City of Tualatin

PARTITION APPLICATION: FINDINGS AND RECOMMENDED DECISION

Job Number: PAR 14-03, 8635 Sagert
Location: 8635 SW Sagert Street, TLID 2S123DD01900
Applicant: Brian Bussanich
PO Box 4183
Tualatin, OR 97062
Owners: Brian Bussanich
PO Box 4183
Tualatin, OR 97062

PRELIMINARY PLAT PLAN

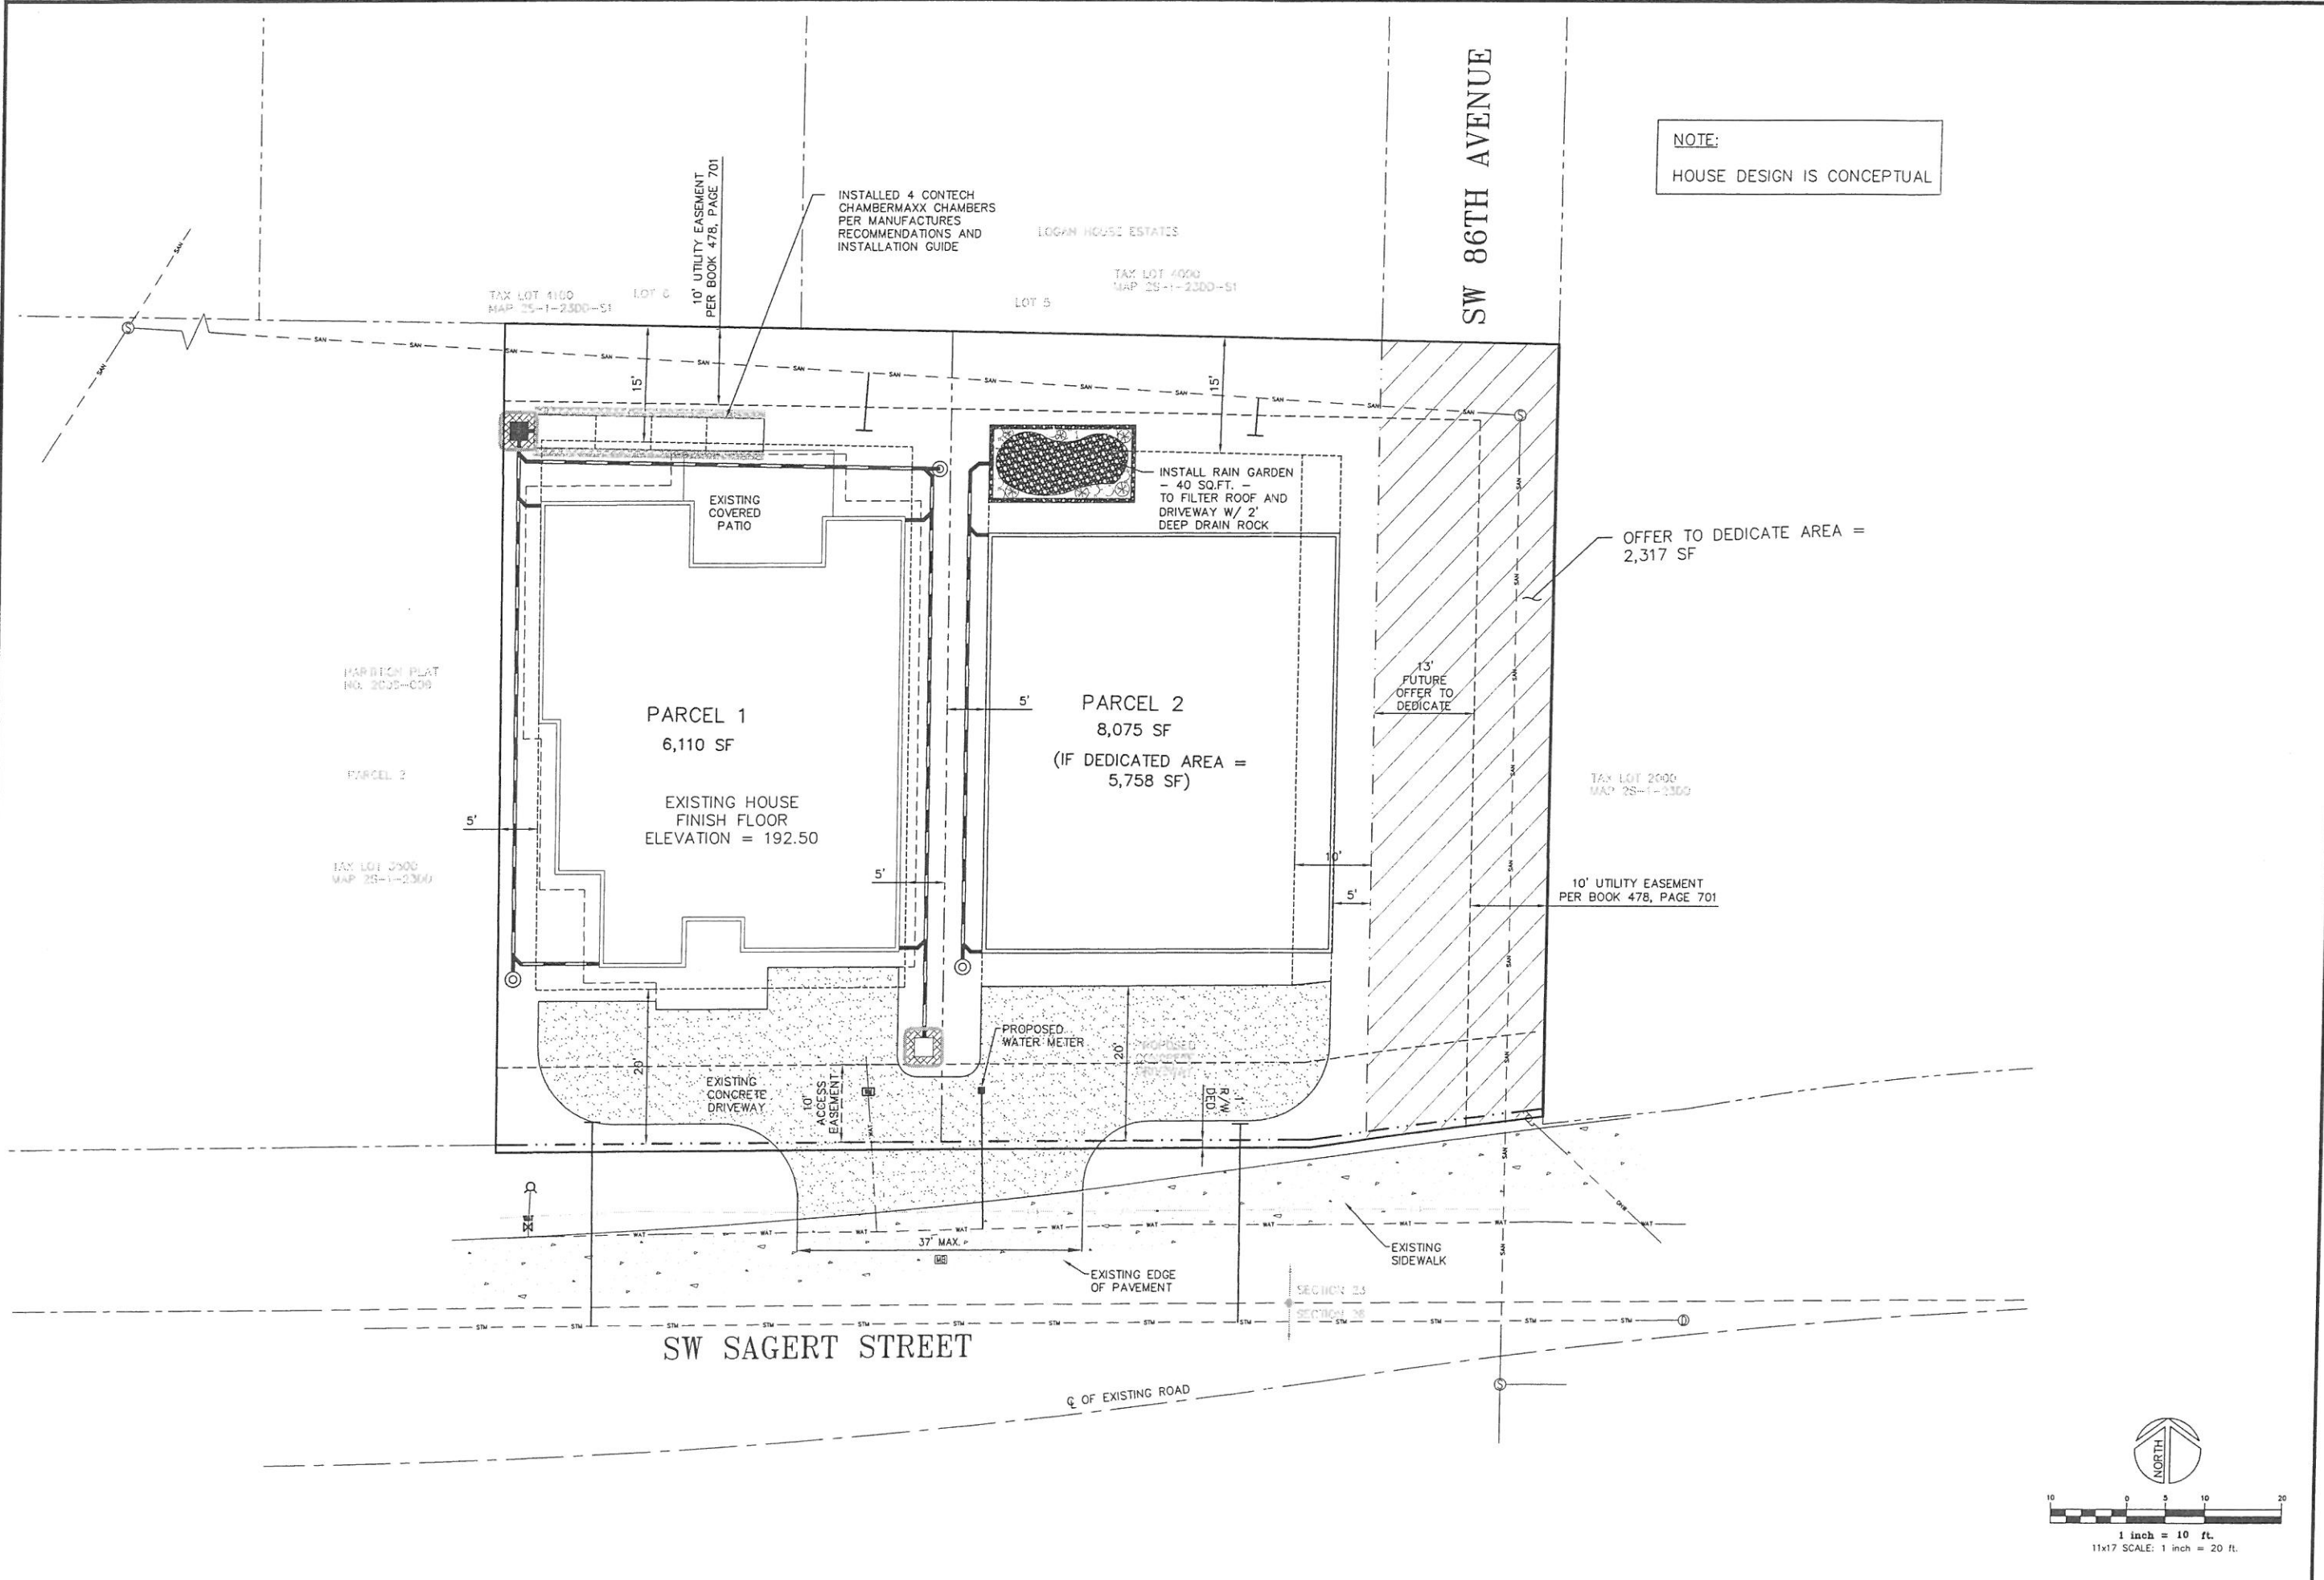
The right-of-way width of SW Sagert Street south of centerline appears to be 38 feet along the frontage of the subject property and is improved with sidewalks, bike lanes, and two travel lanes. By creating only two parcels, the impacts of the proposed development are minimal; as a result, dedication of additional right-of-way needed for full build-out is not required. In an effort to further the Transportation Plan goals and to match the right-of-way of surrounding development, the applicant shall dedicate the additional right-of-way to provide a total of 39 feet from the centerline of SW Sagert Street. The plans show this amount of dedication. This is acceptable. The applicant will need to submit final plans that show a total dedication of 39 feet from centerline of SW Sagert Street, for review and approval. The applicant will need to dedicate 39 feet from centerline of SW Sagert Street, for review and approval.

The plans show an existing 20-foot wide access to SW Sagert Street for Parcel 1 and a nearby 23-foot proposed access for Parcel 2. In order to have access to SW Sagert Street, Parcel 2 needs to share the access with Parcel 1. Residential accesses for three or more garages can be up to 37 feet wide. The plans do not reflect a shared access.

The plans do not show construction of SW 86th Avenue at this time as access is obtained through a shared driveway to SW Sagert Street. The plans show reservation of 23 feet from centerline. This is acceptable. The applicant will need to submit final plans that show reservation of 23 feet from centerline for SW Sagert Street, for review and approval.

The applicant will need to submit revised plans that show a shared access to SW Sagert Street for both parcels up to 37 feet wide, for review and approval. The applicant will need to submit a shared access agreement for the access to SW Sagert Street, for review and approval.

- *The applicant shall submit final plans that show a total dedication of 39 feet from centerline of SW Sagert Street, for review and approval.*
- *The applicant shall submit revised plans that show a shared access to SW Sagert Street for both parcels up to 37 feet wide, for review and approval.*
- *The applicant shall submit final plans that show reservation of 23 feet from centerline for SW Sagert Street, for review and approval.*
